## **URGENT MEDICAL DEVICE UPGRADE NOTIFICATION**

### **RE: STRYKER SONOPET CONSOLE**

July 11, 2014

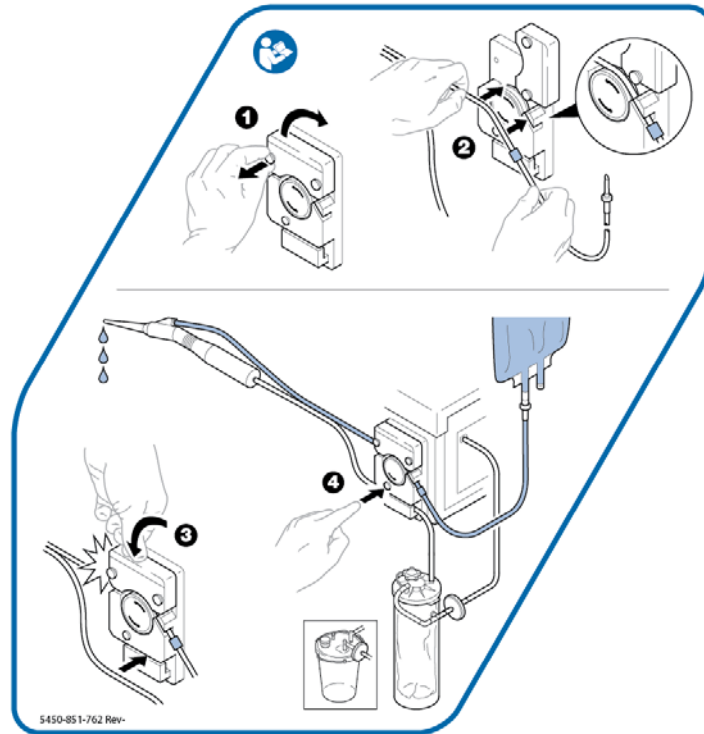
Stryker is sending you this URGENT MEDICAL DEVICE UPGRADE NOTIFICATION to update documentation to clarify how to set up a Sonopet system. This label upgrade includes an update to the Instructions for Use (IFU) and an on-device instructional label for proper irrigation set up.

- DO NOT use a rigid non-collapsible irrigation container. Failure to comply may cause the flow of irrigation to be drastically reduced and result in overheating of the handpiece tip and/or tip cover. Only use a collapsible irrigation container.
- The irrigation tube must be properly routed through the irrigation pump with the pump cover fully closed and latched. Improper setup of the irrigation tubing may result in an inconsistent or lack of irrigation.
- Provide adequate irrigation to the tip to avoid excessive heat that could result in tissue damage due to unintended contact.

All existing Sonopet consoles will have an instructional irrigation setup label applied to the side of the console.
